## HISTORIC AND DESIGN REVIEW COMMISSION

**HDRC CASE NO:** 2015-451  
**ADDRESS:** 528 RIVERWALK  
**LEGAL DESCRIPTION:** NCB 148 BLK LOT W 10.7 FT OF 5, S 119.66 FT OF 6 & 6.5  
**ZONING:** D H HE RIO-3  
**CITY COUNCIL DIST.:** 1  
**DISTRICT:** Alamo Plaza Historic District  
**LANDMARK:** Bennett / River Square Bldg / Atwell Addition  
**APPLICANT:** Jose Sanchez/The Original Mexican Restaurant  
**OWNER:** The Original Mexican Restaurant  
**TYPE OF WORK:** Menu board attached to hostess station  
**REQUEST:**

The applicant is requesting a Certificate of Appropriateness for approval to install a menu board at the Riverwalk level.

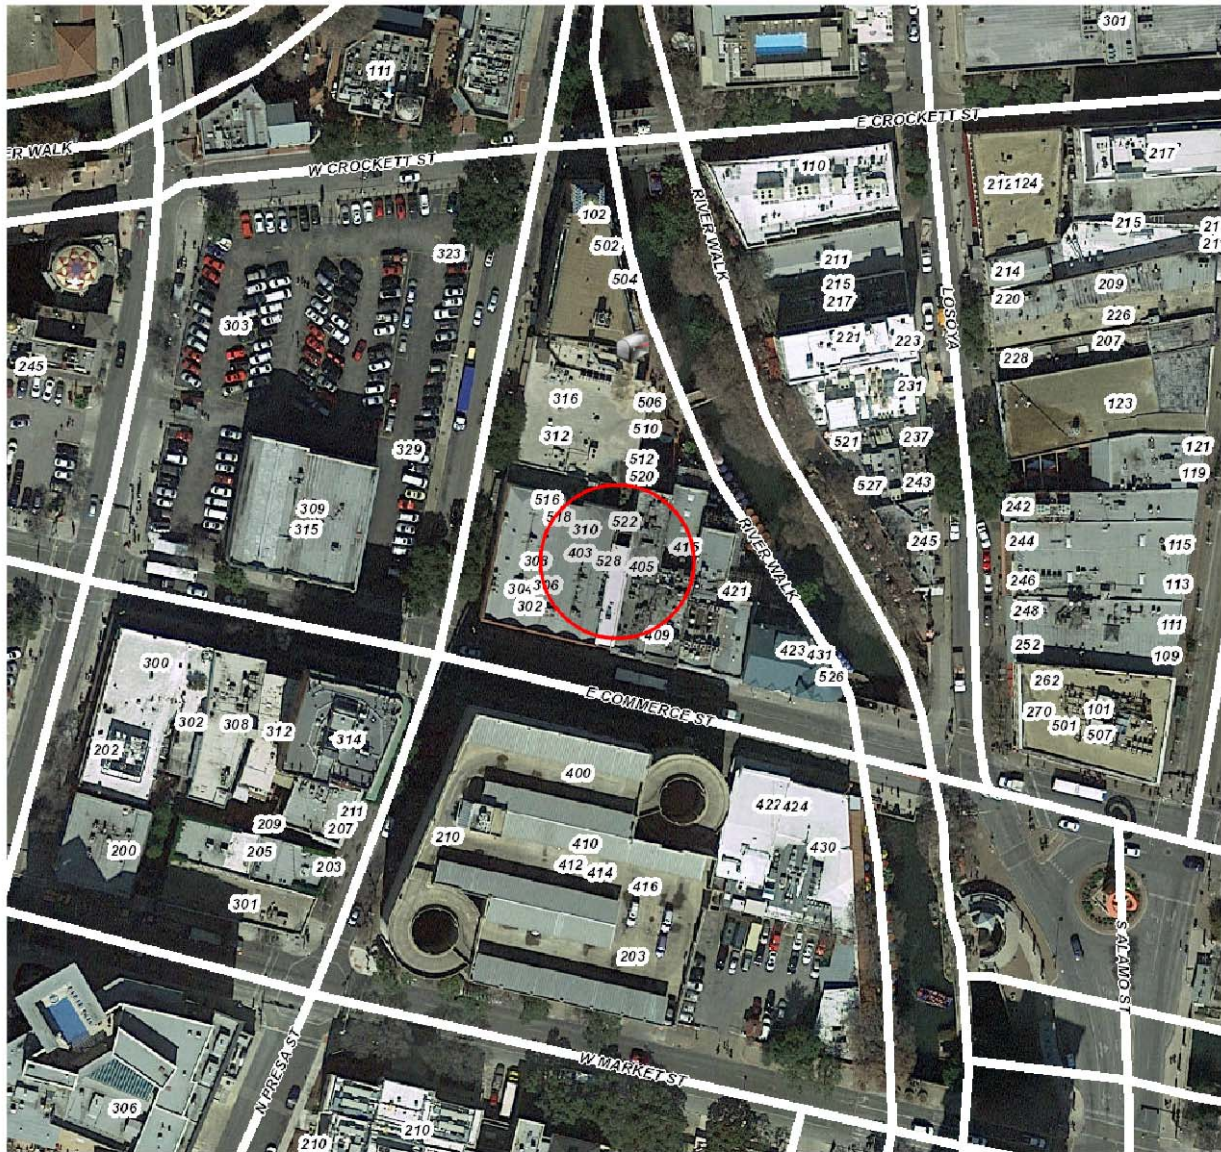
- a. The applicant has proposed to mount a menu board to a non permanent hostess station at the Original Mexican Restaurant located at 528 Riverwalk. The applicant has proposed the menu board's display area to be two feet in width by two feet in height. The UDC allows for menu boards to be no larger than two (2) square feet. This applicant's proposal is not consistent with the Guidelines.
- b. Per the UDC Section 35-678)(g)(2), permanently displayed menus may be properly installed inside the business' window or in an approved wall-mounted or freestanding display case adjacent to the business entrance. The applicant has proposed to mount the proposed menu board to a hostess station, which includes dimensions greater than allowed by the UDC. This is not consistent with the Guidelines.

Staff does not recommend approval. Staff recommends that the applicant propose a menu board that is permanently located near the restaurant's entrance that does not exceed two (2) square feet.
